PARKLANDS VILLAGE 2 PHASE 2

DATE:
06/07/2023 SITE PLAN 01

SHEET TITLE:
LANDSCAPE
PLAN

PARKLANDS VILLAGE 2 SUBDIVISION FILING NO. 2

L-118
SHEET 51

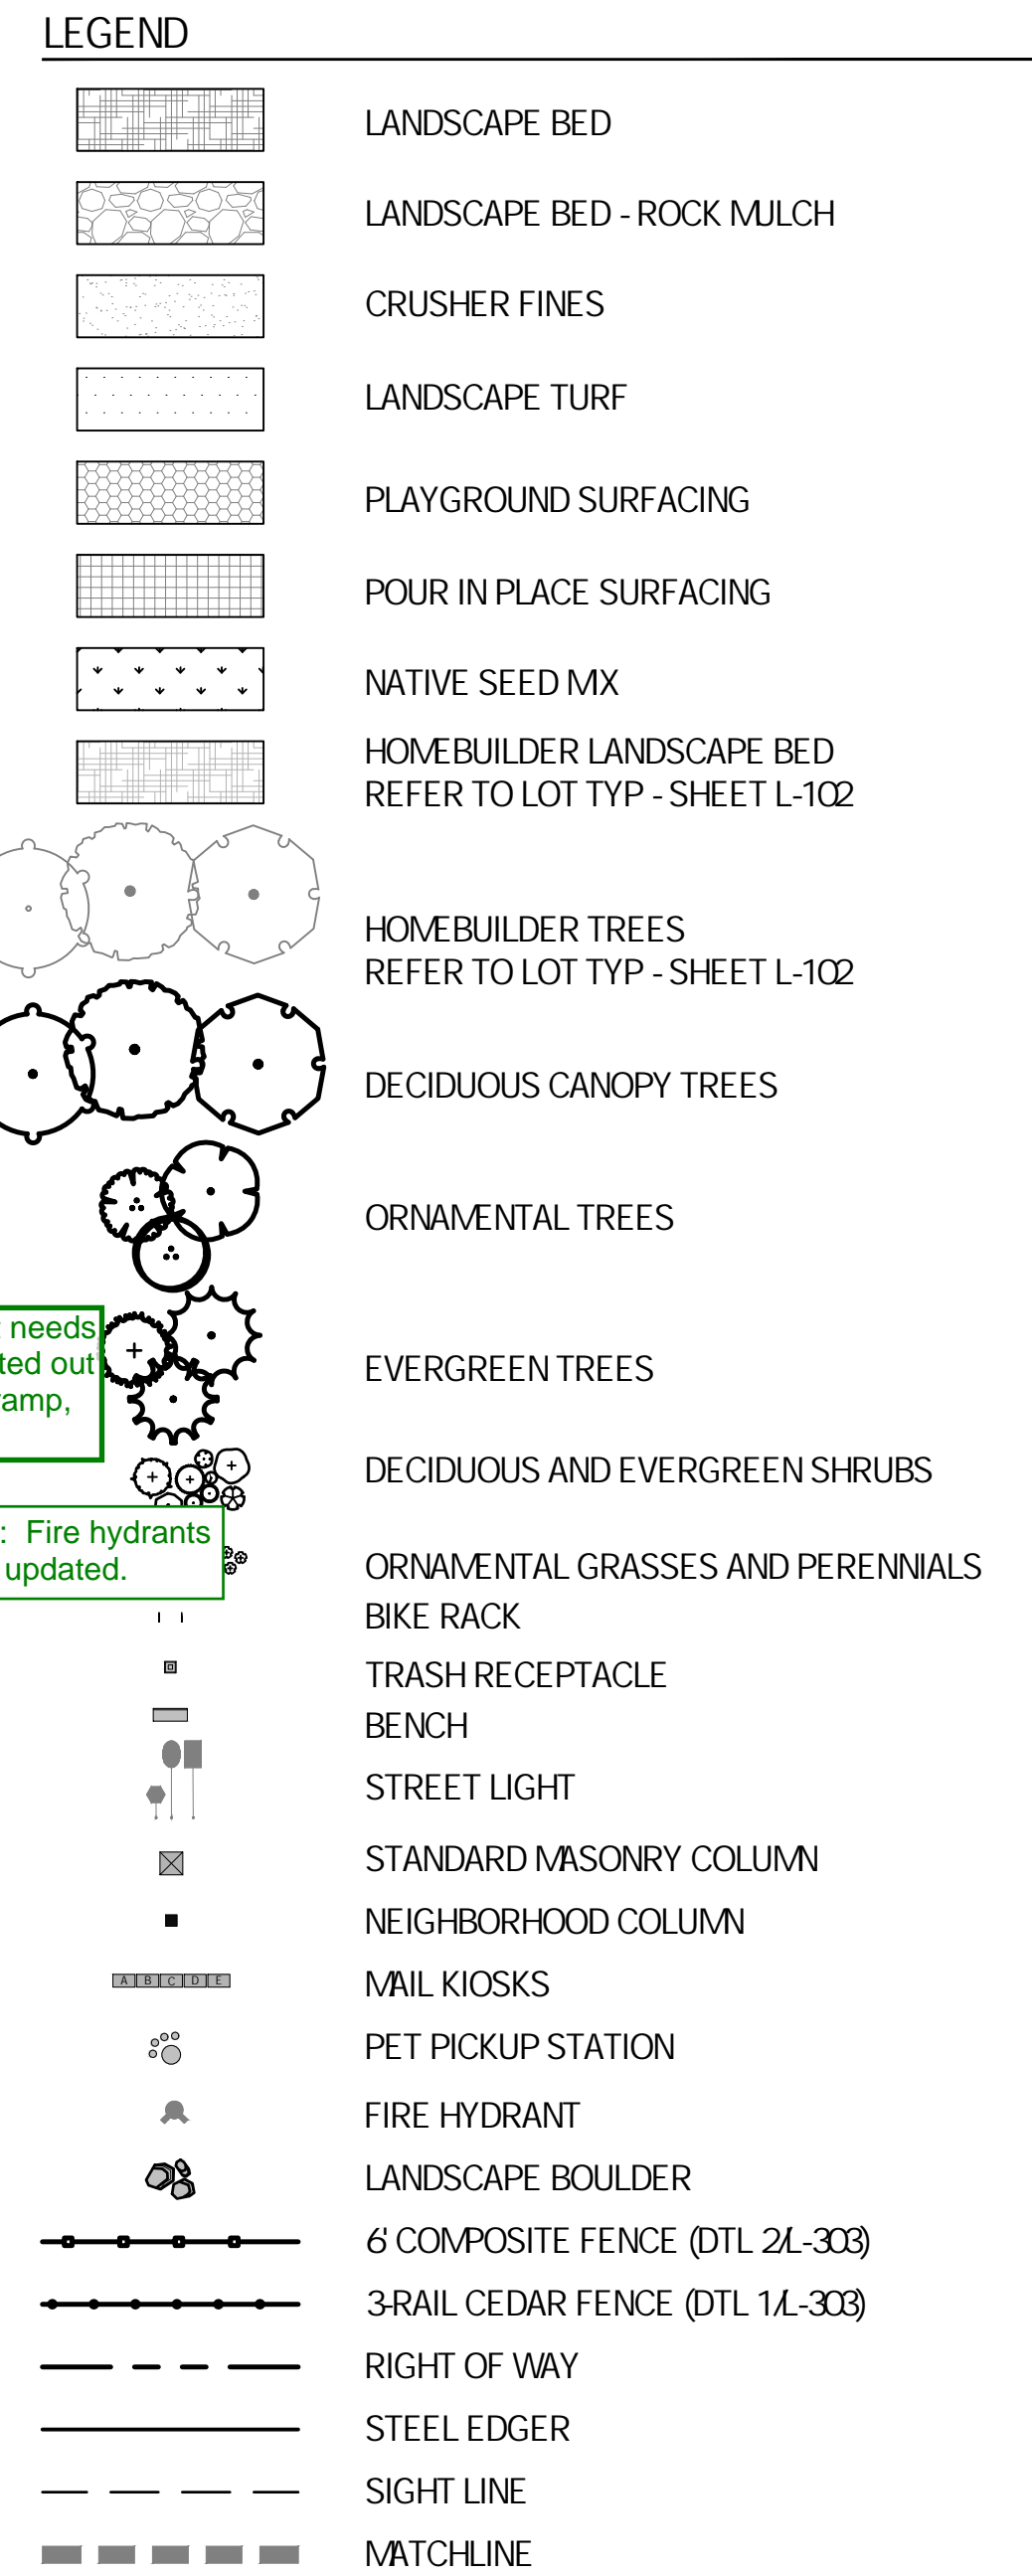
fix name, typ. ALL

Response: Name types
have been updated.

L-119
SHEET 52

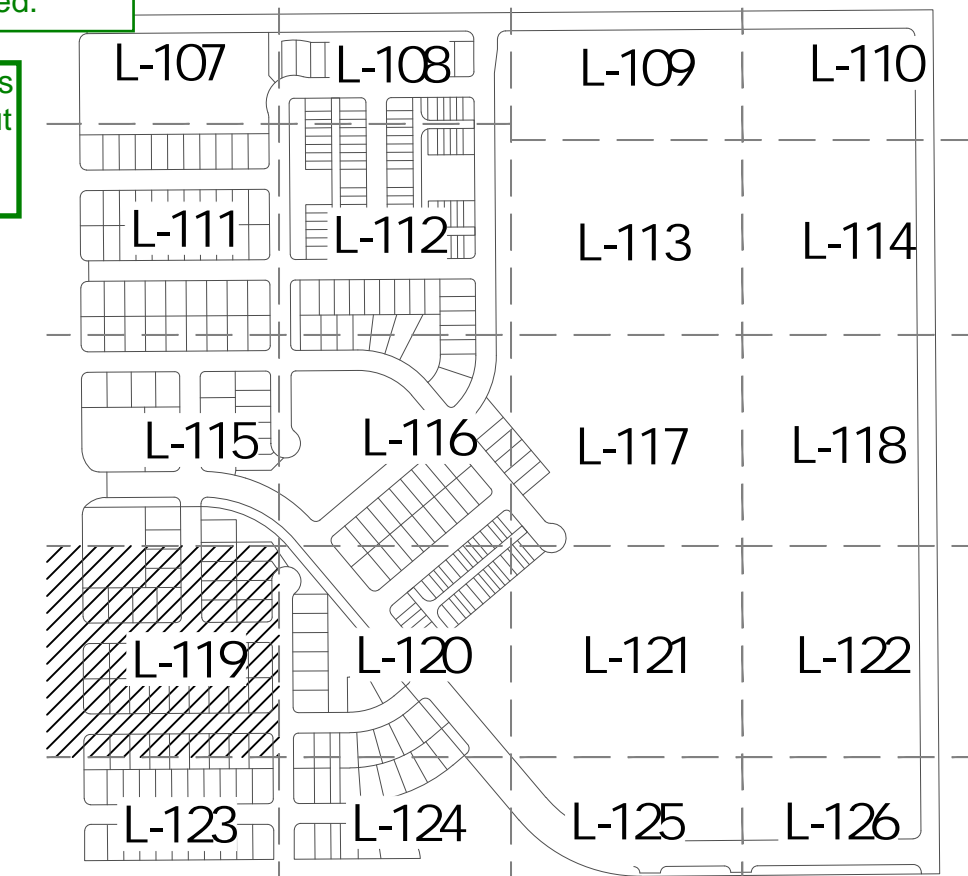
Fire hydrant needs to be relocated out of the curb ramp, typ. ALL

Response: Fire hydrants have been updated.

L-120
SHEET 53

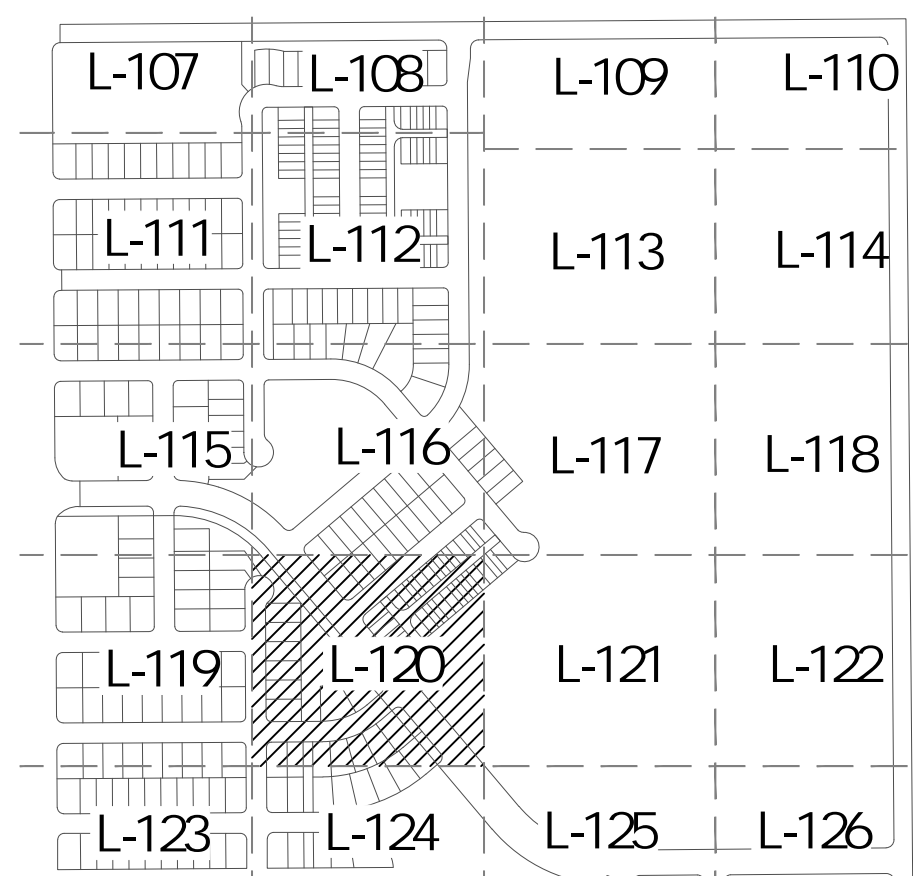
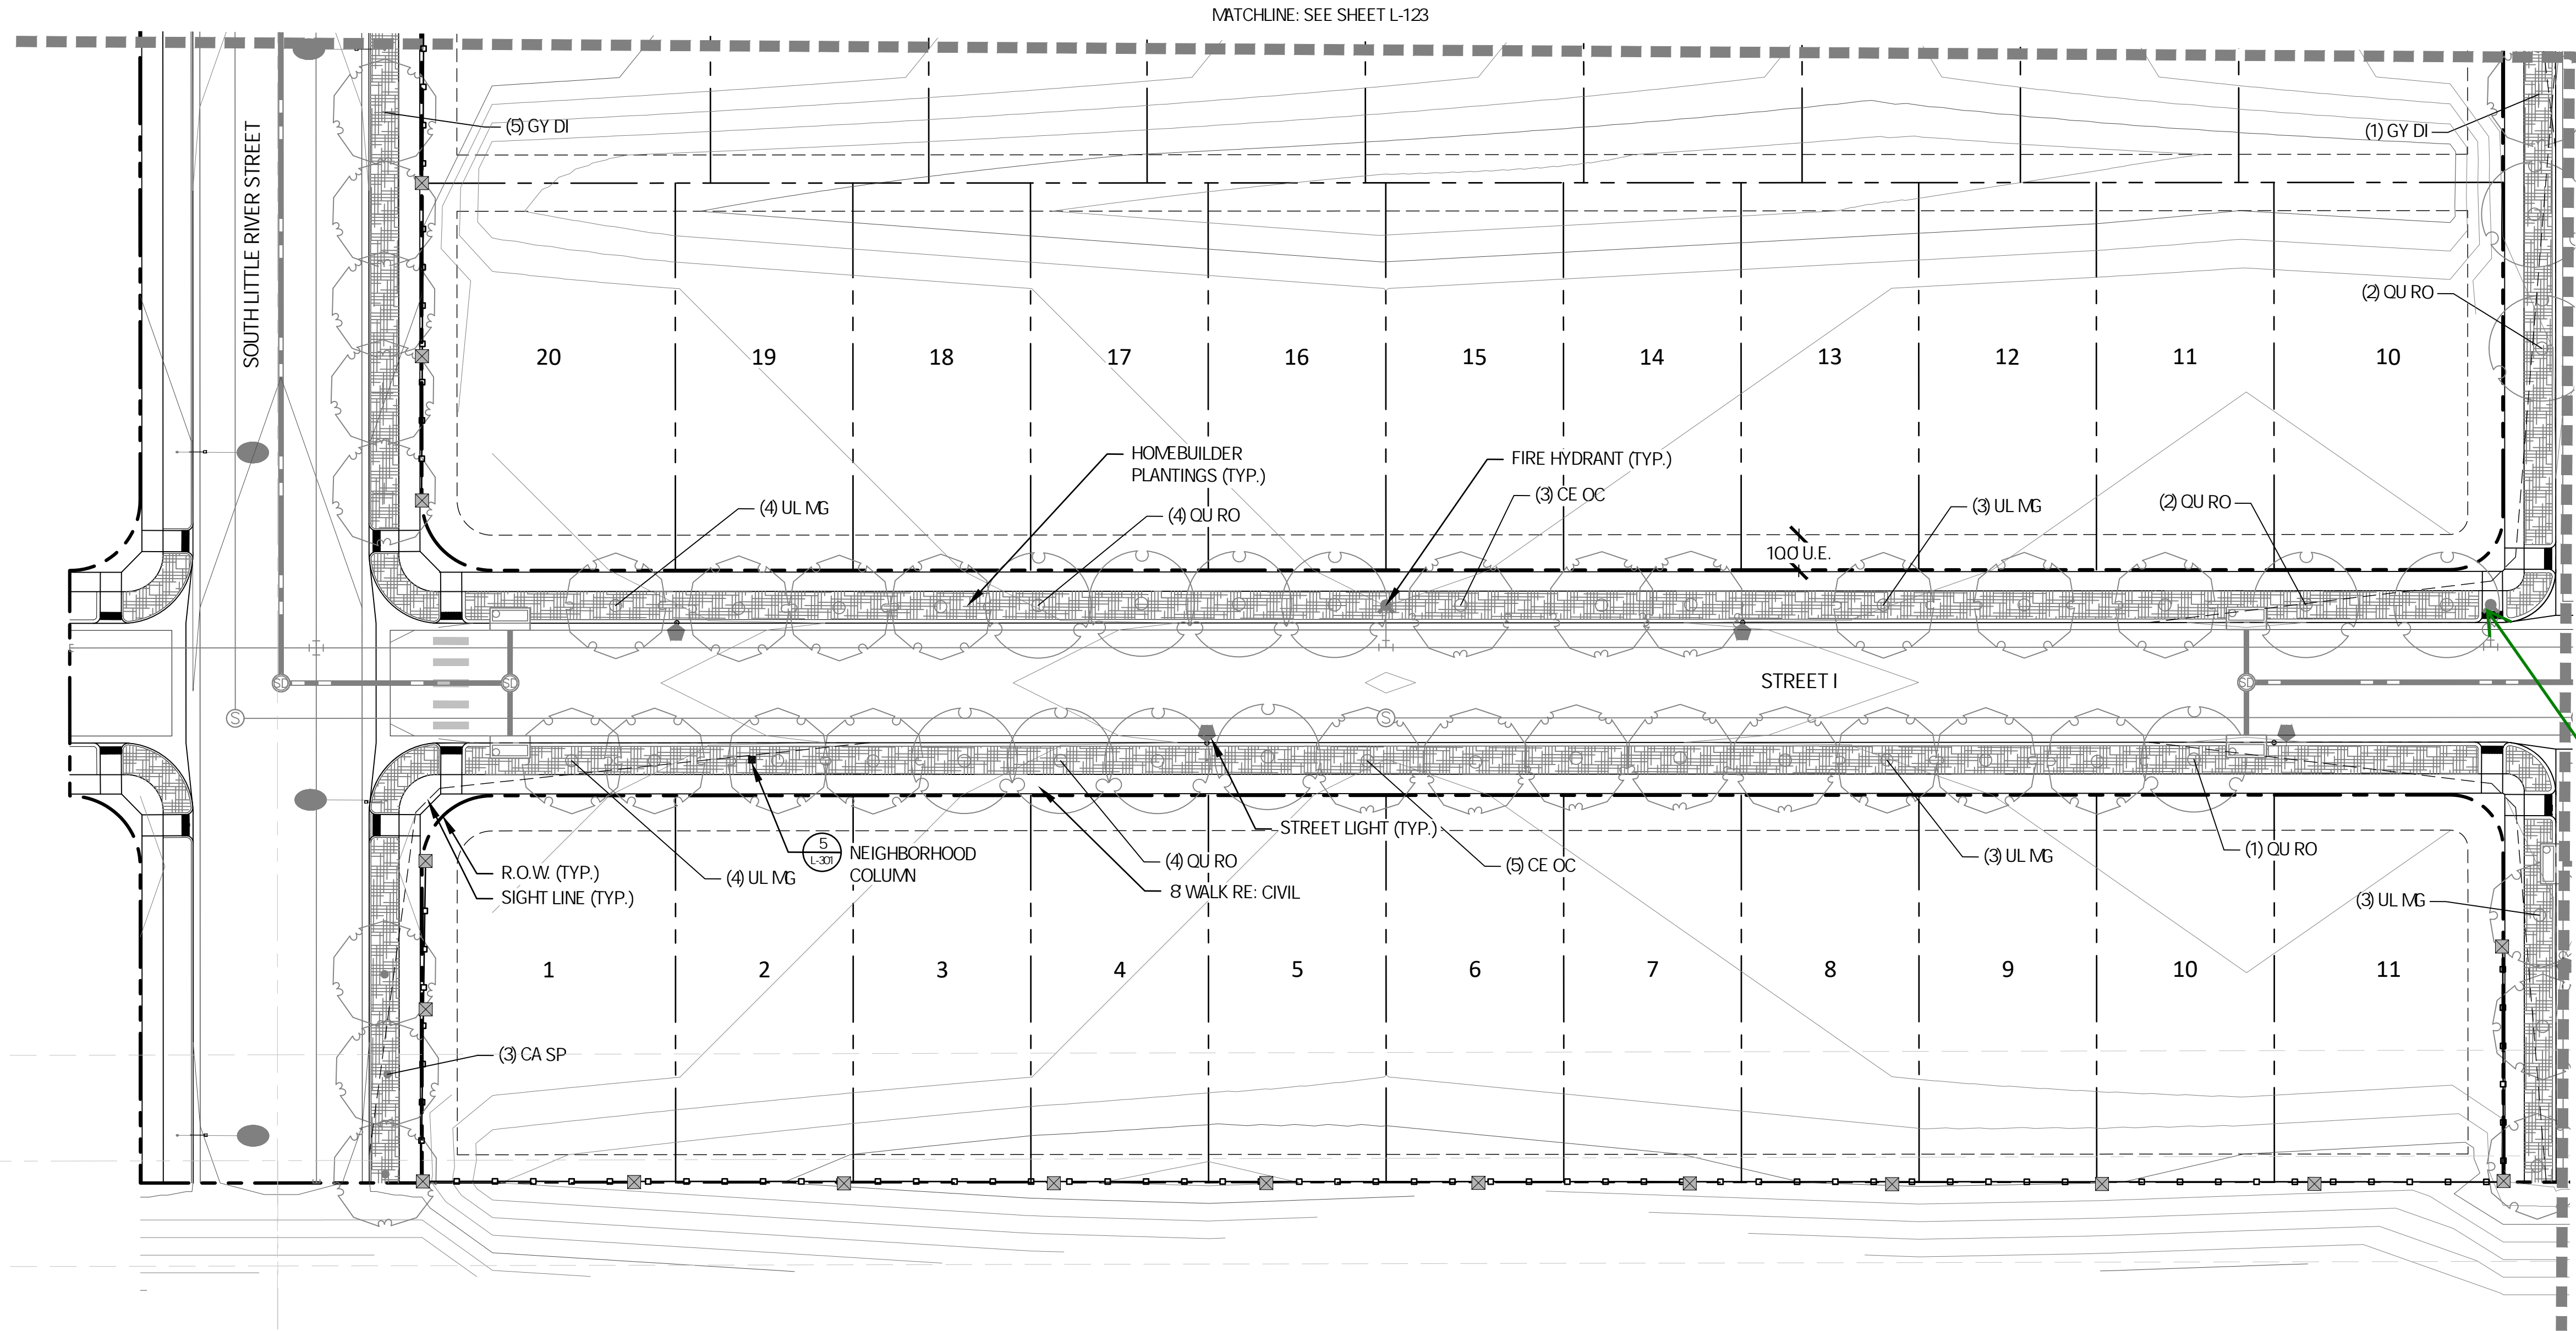
At least 50% of this green court area needs to be usable common space, which can include programmed areas, but should excluded the walk and areas containing landscape plantings. Please provide an insert diagram to demonstrate compliance with this requirement.

If the development to the east for the rest of Tract K is known i.e the layout is defined, then include that in Tract K grayed back and label as future development. Then base the landscape tract area on the remainder of the open space. OR... create a separate tract that includes just the open space/green court areas that have been landscaped.

Is this area expected to be another set of townhomes?

Response: Tracts have been updated to better calculate requirements.

Response: Area has not yet been designed.
